## DEVELOPMENT FACILITATION TEAM

### Planning - Case Comments

**Project Number:** PR-2023-009368

**Project Name:** Farolito Senior Community

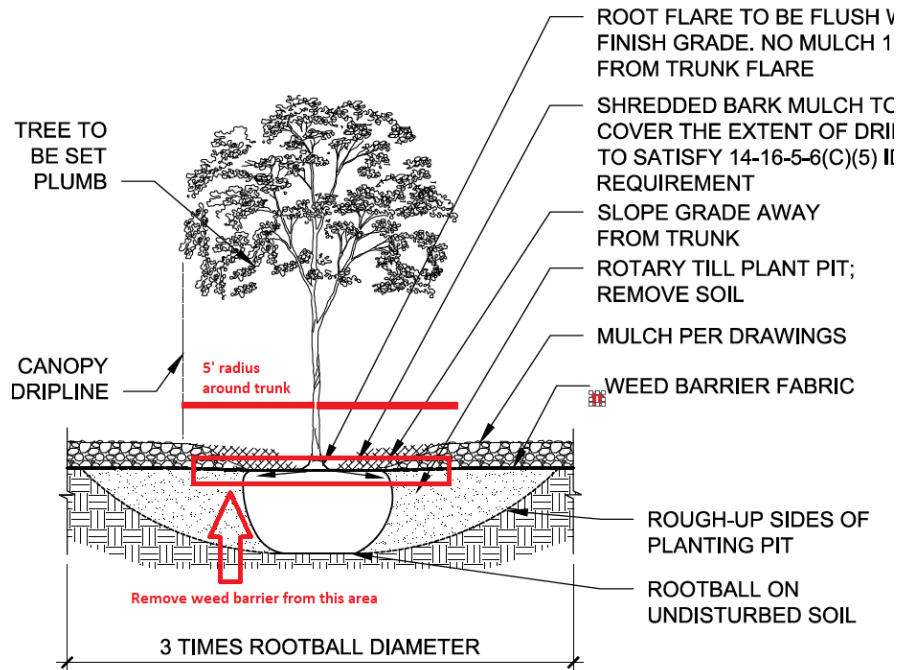
**-Repalce the Raywood ash with Urbanite Ash, Autumn Blaze maple with Bigtooth maple, and Austrian Black pine with Italian Stone pine.** Addressed-DPS.

**-Change the trees under the overhead distribution line along the north edge of the project to Golden rain trees and Russian hawthorns.** Addressed, planting was arranged to meet new plant sizes.

**-Of the two different locust trees you have proposed, choose one type only and spread them in the site so no two locust trees are adjacent to one another, because of the appearance of the beetle that has been killing locust trees.** Addressed, all Locusts are now Purple Robe Locusts, none are next to each other- DPS.

A general note was added to address the locusts, as for the fruit trees, this client specifically requested an orchard on the property for their residents. They have prepared for the proper care and maintenance required. -DPS
